**Subject** ▶ Change of Side Handle

**For Models** ▶ HM1303, HM1303B

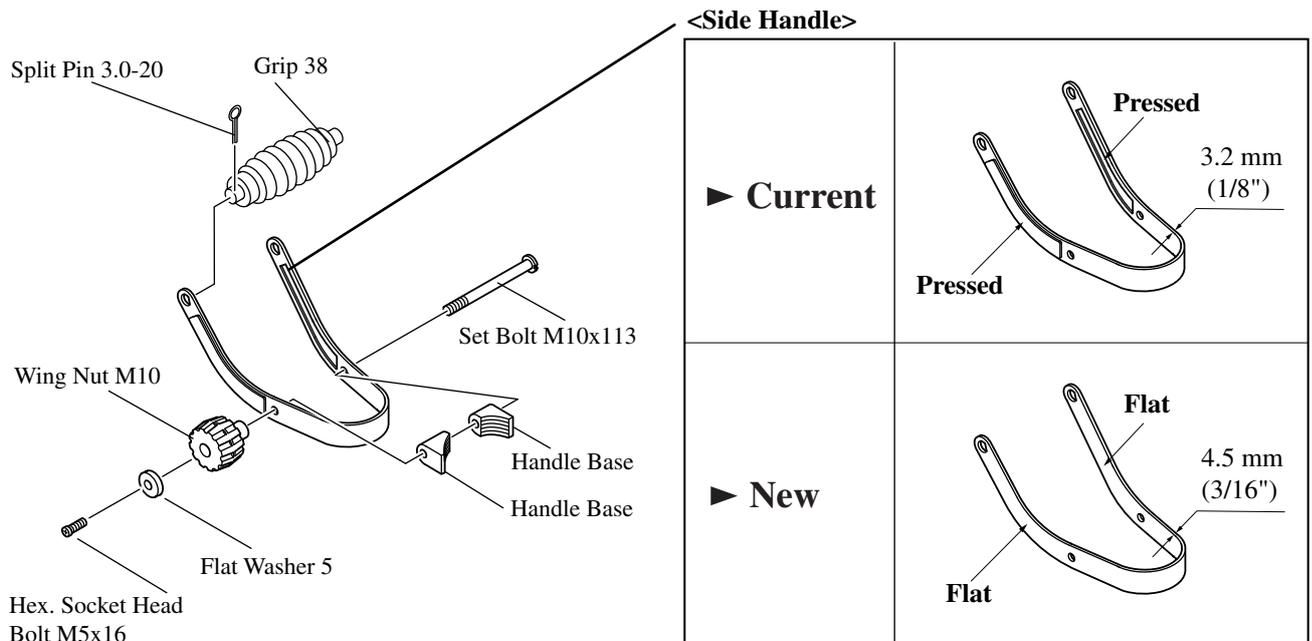
**Description** ▶ To increase the durability of Side Handle, the following have been implemented.  
 1) The thickness of Side Handle has been changed from 3.2 mm (1/8") to 4.5 mm (3/16").  
 2) Pressing has been eliminated from manufacturing process of Side Handle.

Item No.	Current part		Q'ty	I/C	New part		Q'ty	Note
HM1303: 065	Side Handle		1	←	Side Handle		1	
HM1303B: 067	344390-4				345233-3			
B01	Side Handle Assembly		1	←	Side Handle Assembly		1	See the note below.
	134924-9				134949-3

**Side Handle Assembly** consists of Side Handle, Set Bolt M10x113, Handle Base (2 pcs.), Wing Nut M10, Flat Washer 5, Hex. Socket Head Bolt M5x16, Split Pin 3.0-20 and Grip 38. See the illustrations above.
